DESIGN REVIEW COMMITTEE

AGENDA

**DEPARTMENT OF PLANNING AND ZONING
PLANNER'S REPORT**

1 FRONT ELEVATION
SCALE: 1/4" = 1'-0"

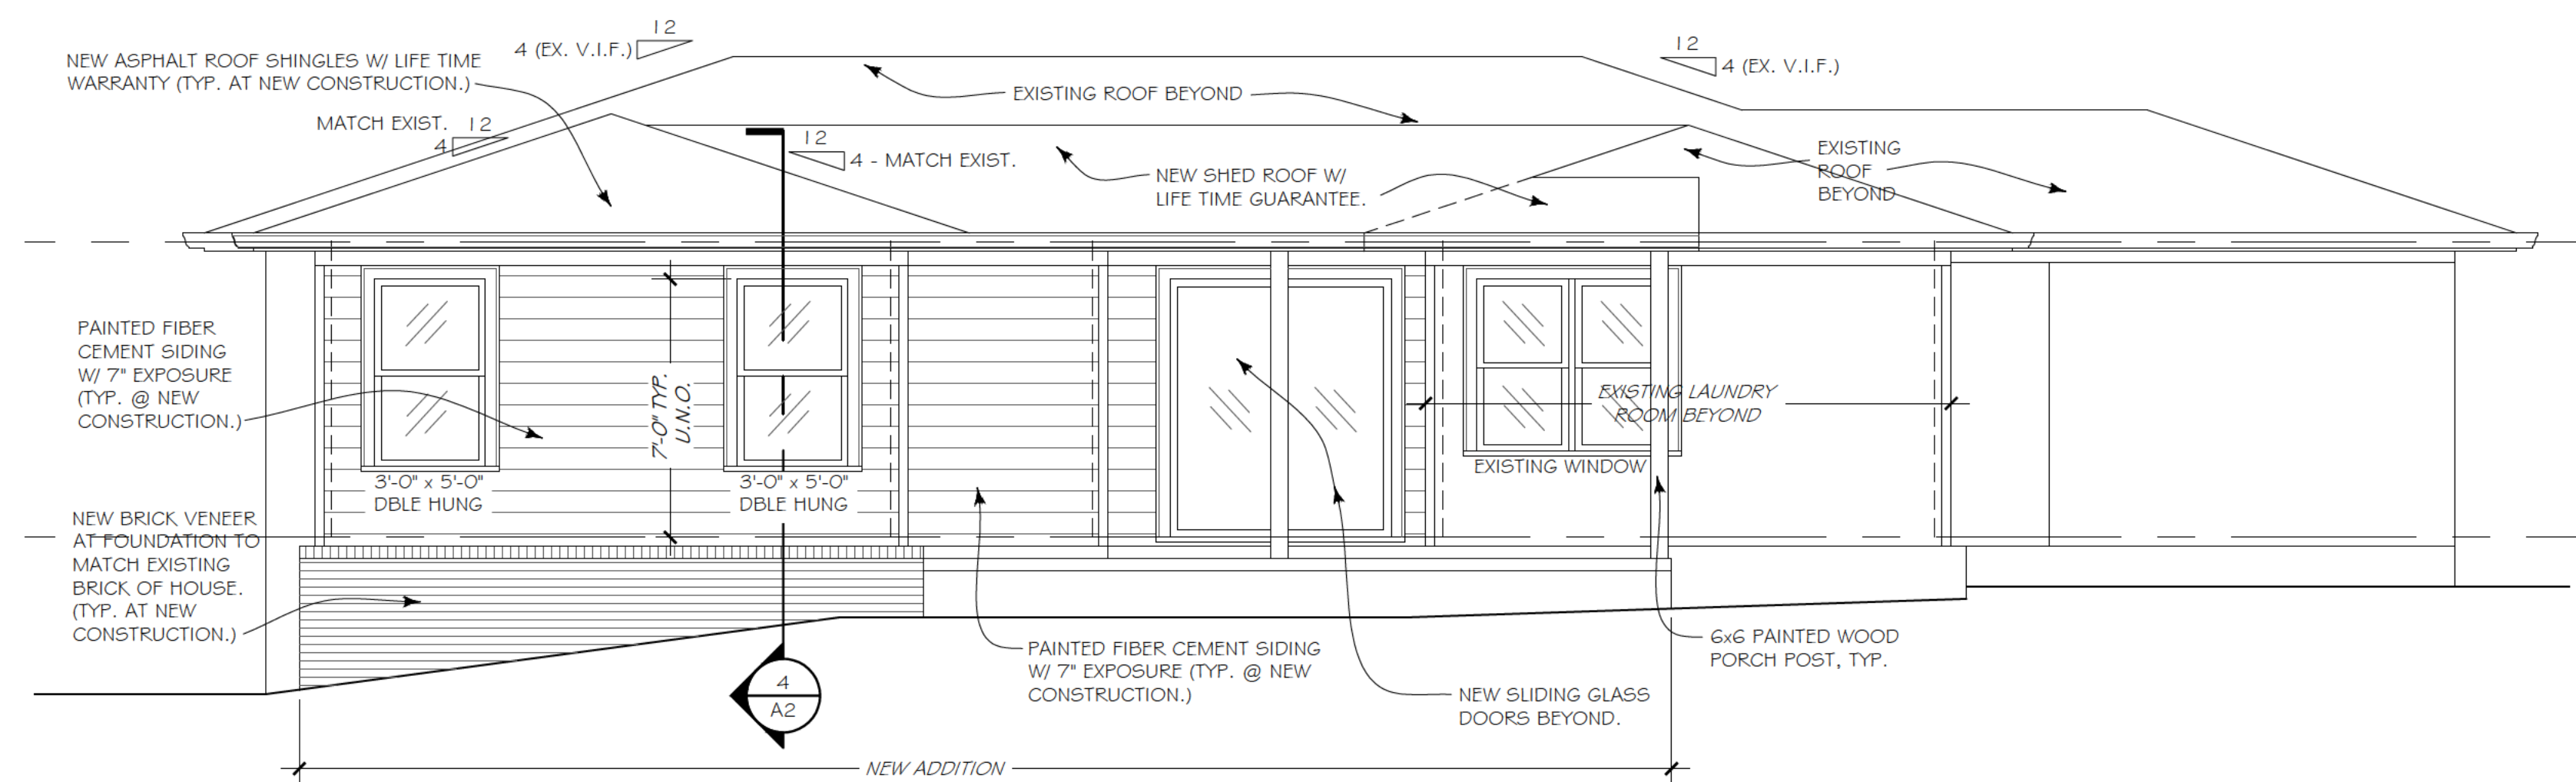
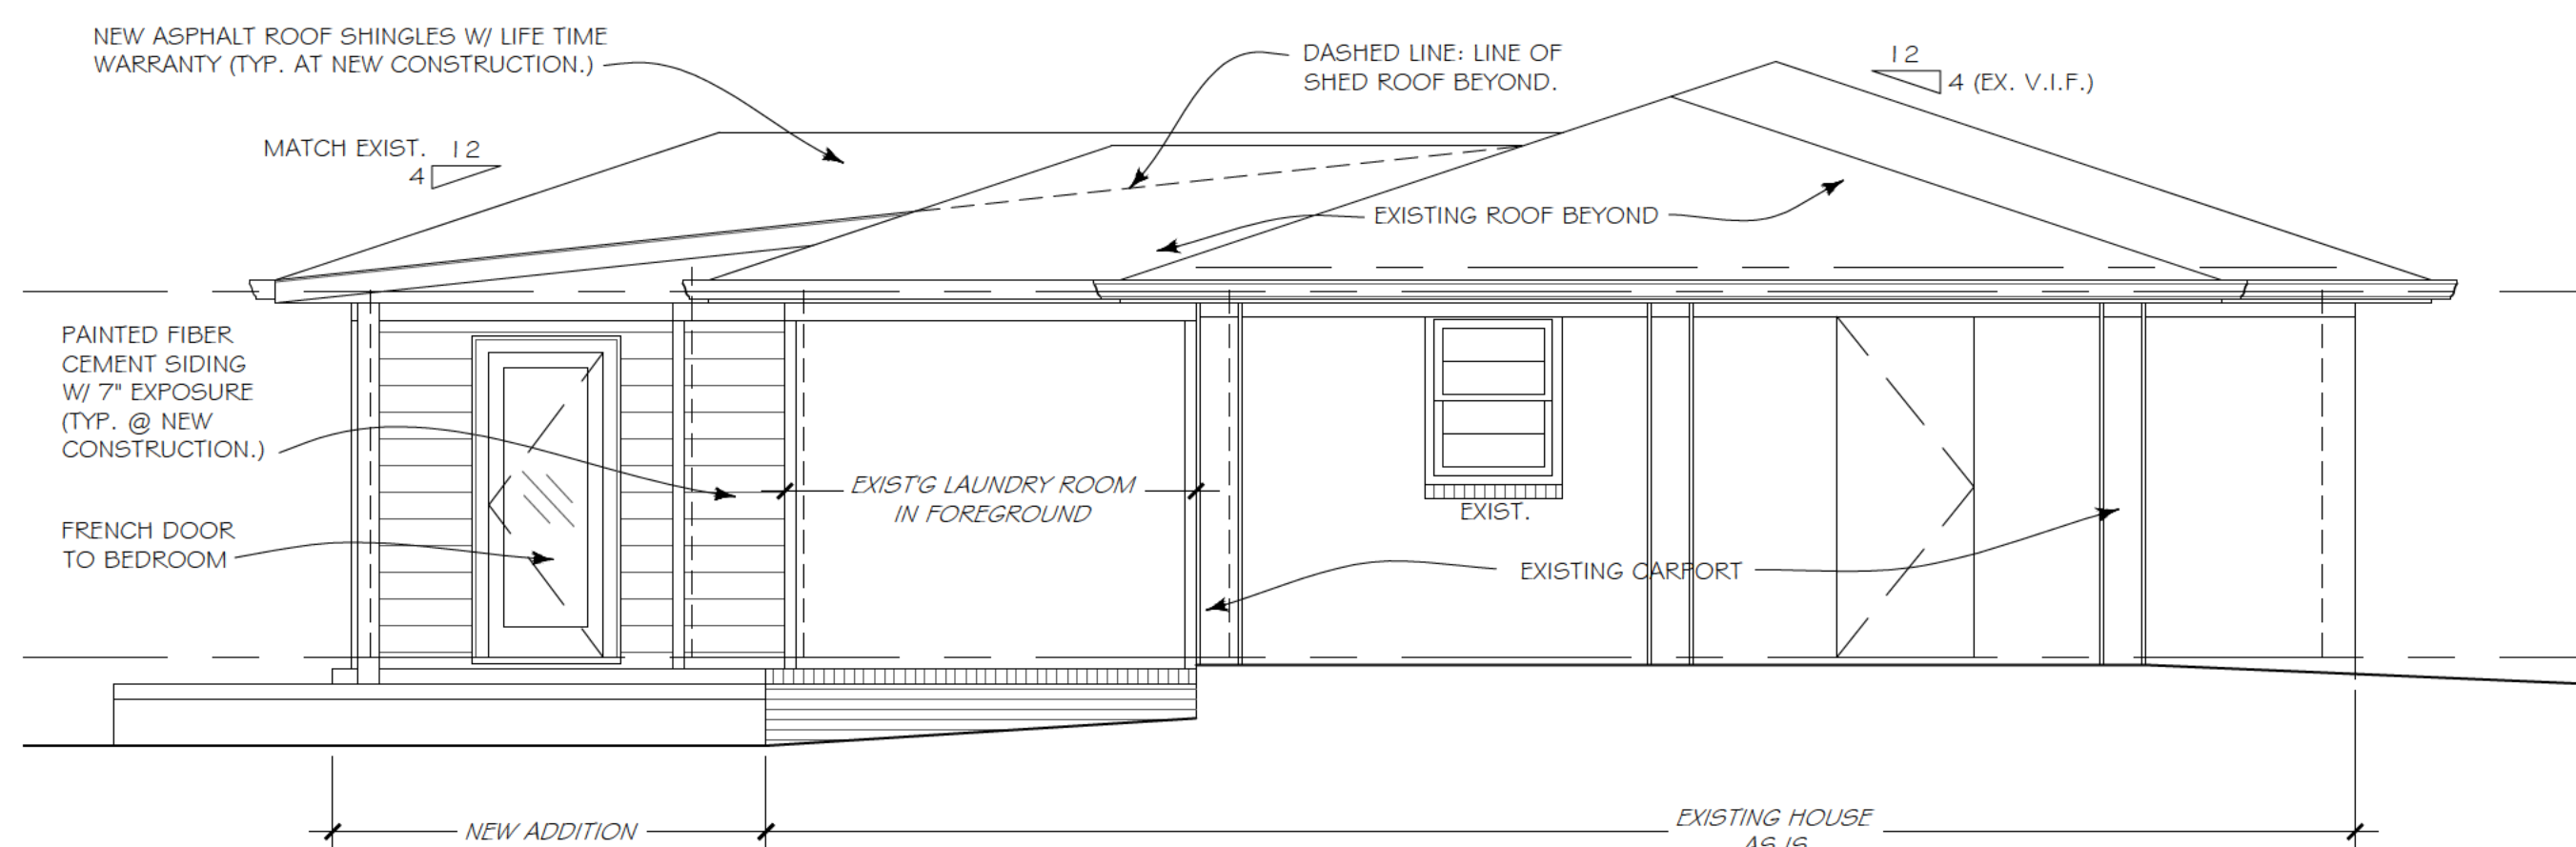
STAFF COMMENT: Roof is being replaced. No detail is provided for the roof overhang or warranty.

STAFF COMMENT: Drawings still show brick – not cementitious siding.

STAFF COMMENT: No walkway shown. No building numbers provided. No detail has been provided for windows. No detail shown for fenestration percentage of façade. No detail has been provided for trim (dimensions) or sills (material).

- **Front light should be shown.**
- **Mechanical not shown but must be screened.**
- **Roof is being replaced. No detail is provided for the roof overhang (12" min required) or warranty (30 yr warranty required).**
- **Gutters and downspouts must meet standards.**
- **Drawings should be updated to show siding, not brick front.**
- **Walkway should be shown.**
- **Building numbers should be provided.**
- **Detail for windows should be provided (recess)**
- **Detail should be shown for fenestration percentage of façade.**
- **Detail should be provided for trim (dimensions) and sills (material).**

1 NEW FRONT ELEVATION
1/4" = 1'-0"

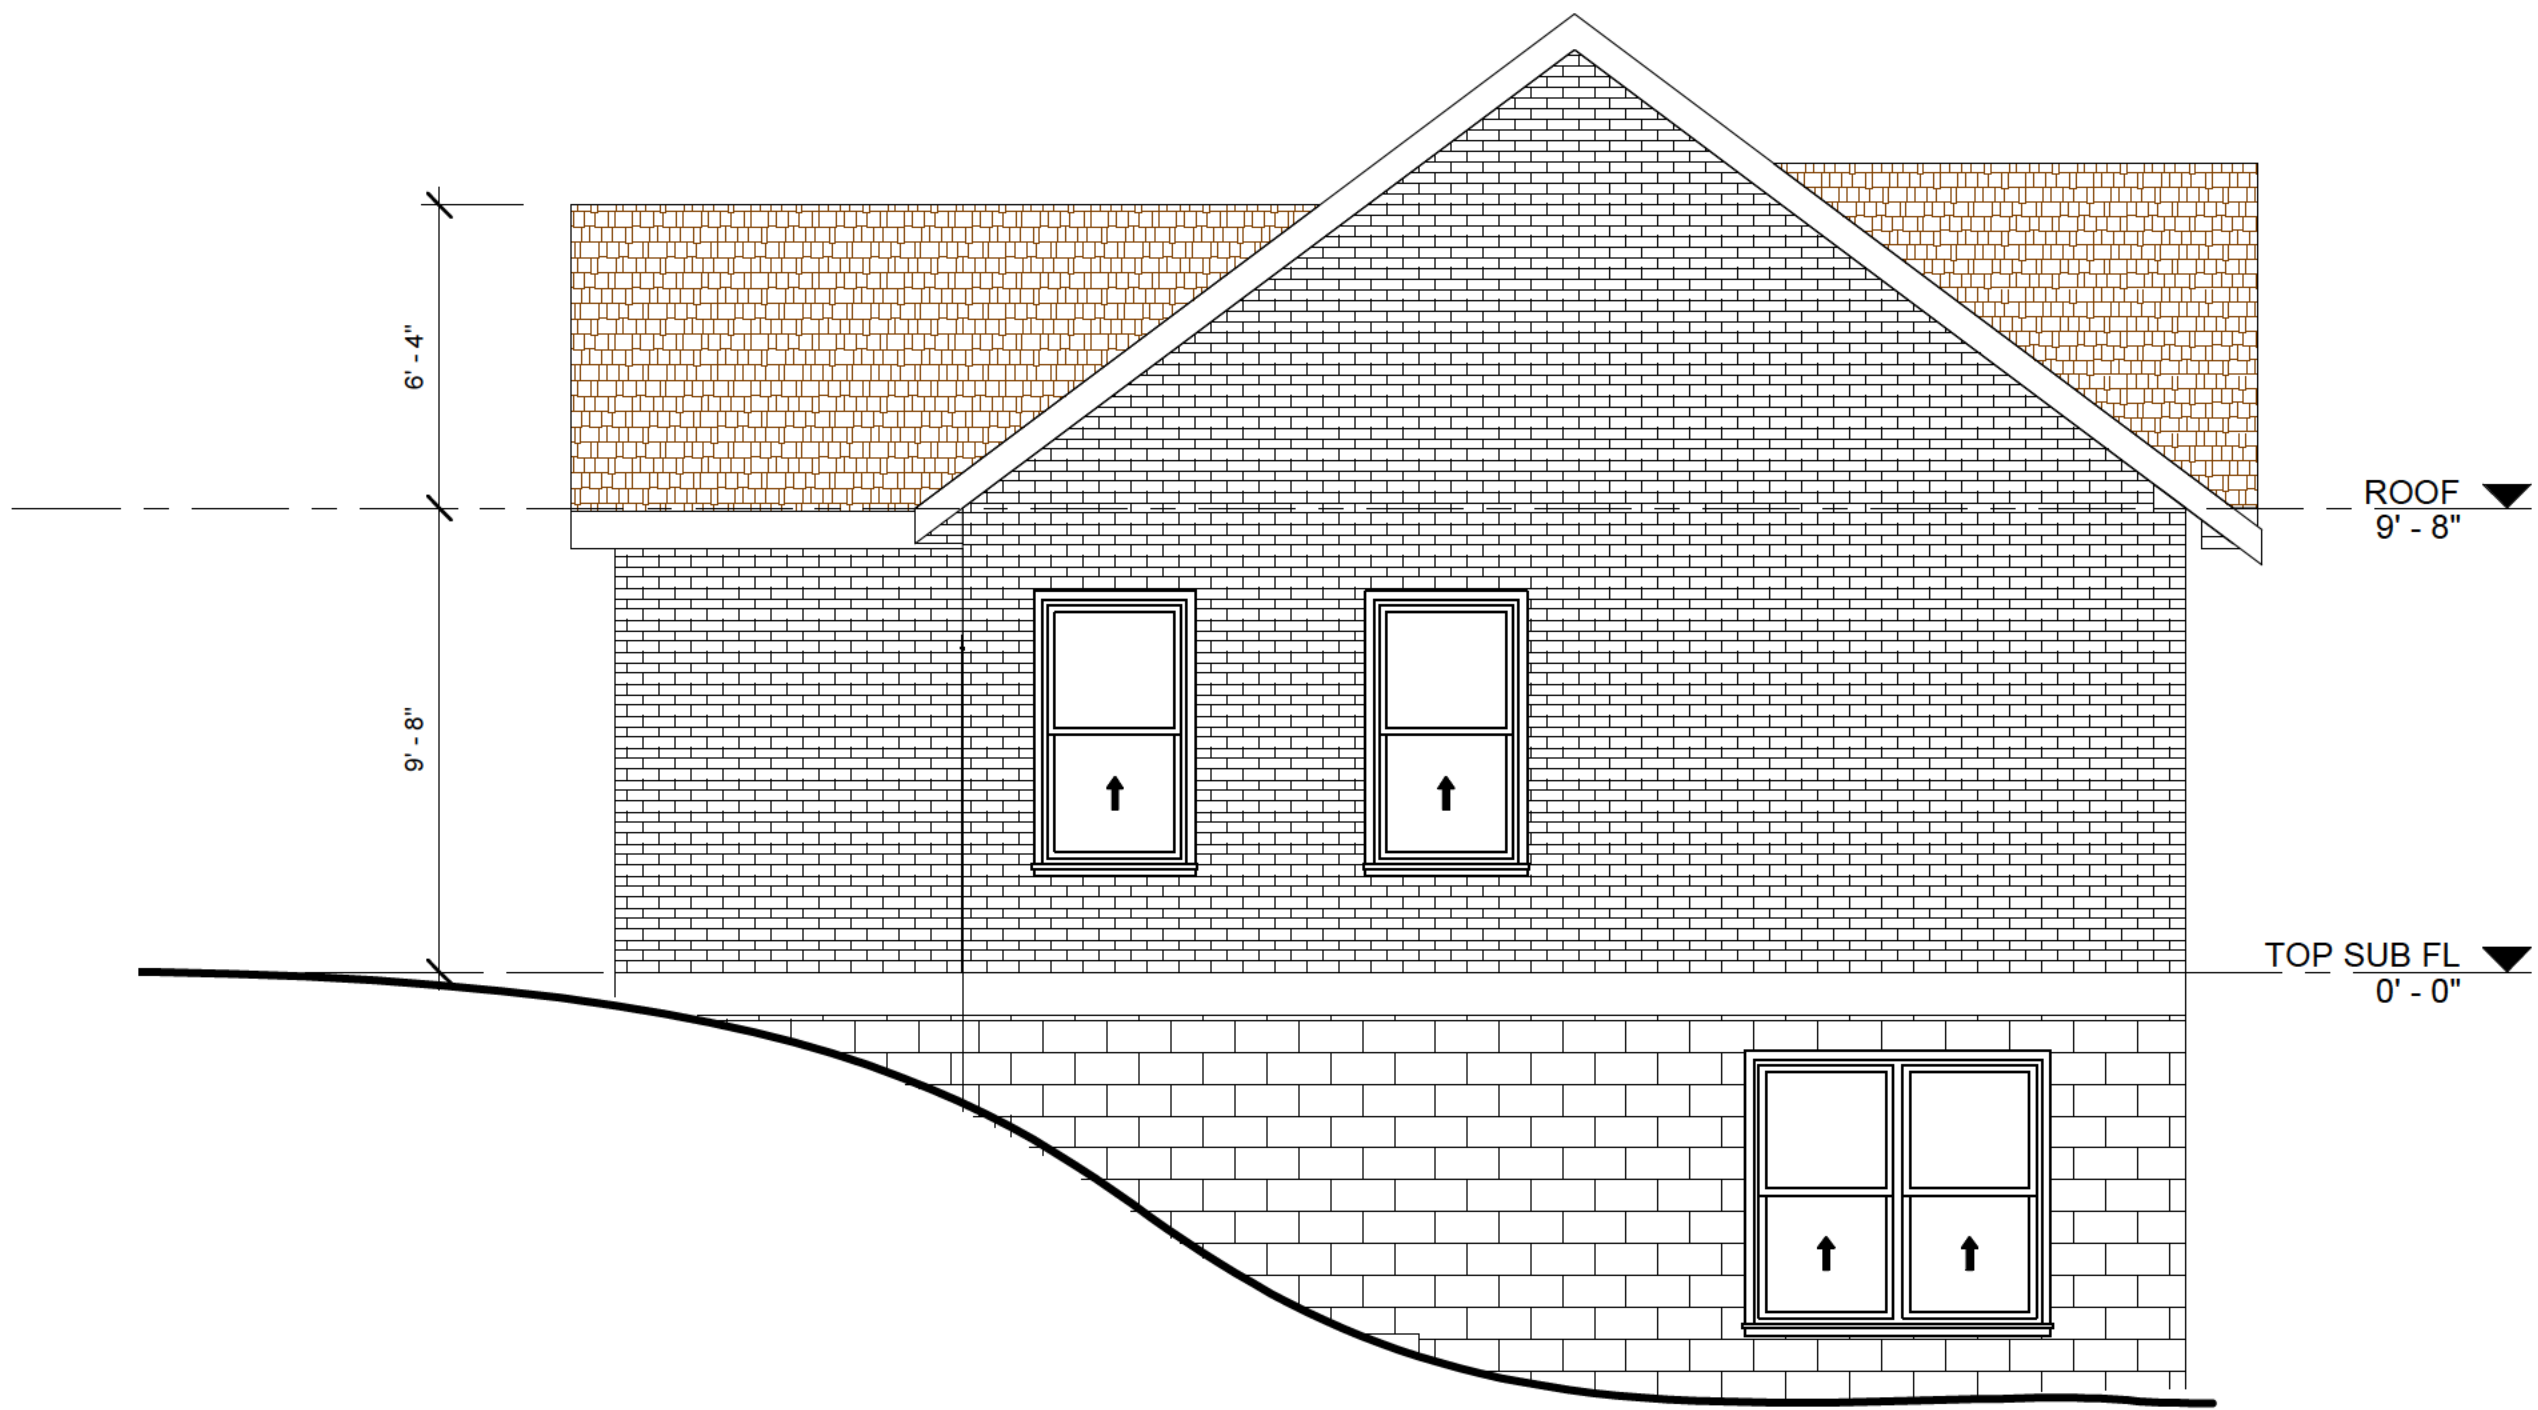
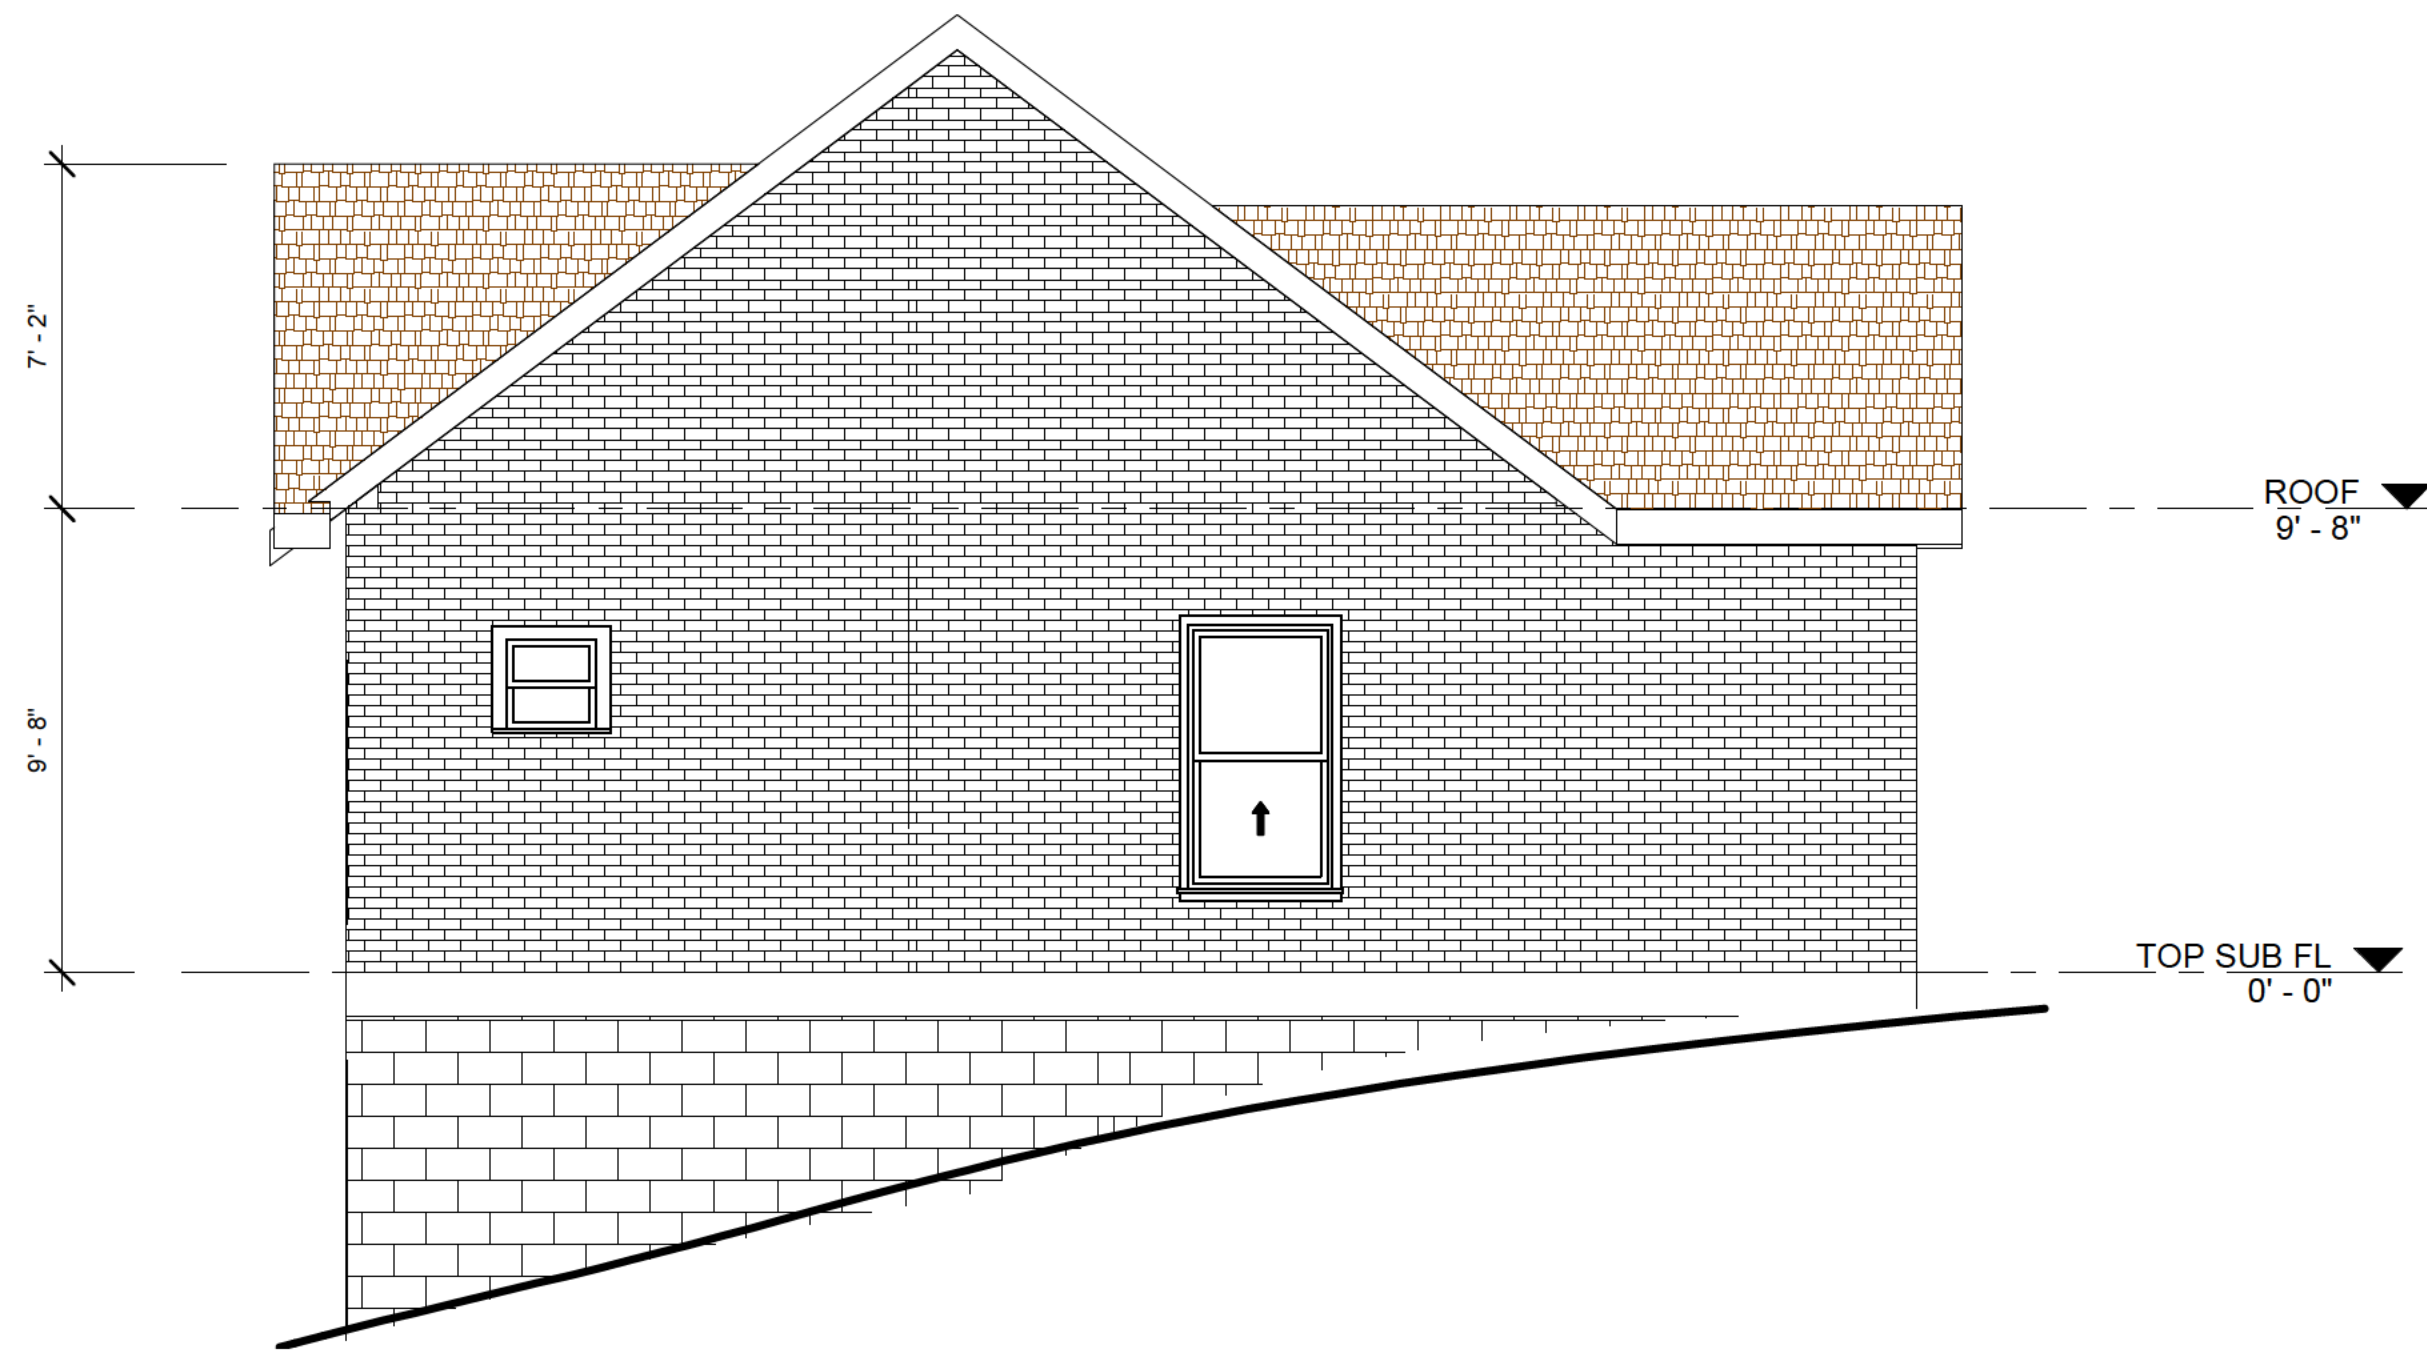
- Chain link visible from the right of way should be replaced.
- The parking in the supplemental area is not compliant. Recommendation is to relocate parking to the rear and replace with landscaping, including street trees or improved parking lot. Remove gravel in supplemental area.
- Any mechanical visible from the right of way must be screened.
- A dedicated walkway should be provided from the entry door to the sidewalk.
- Building numbers should be provided adjacent to the front entry.
- Ensure window tint compliance and window recess
- Dumpsters, if provided, must be screened per standard.
- Material proposed (Trex) does not meet requirement.
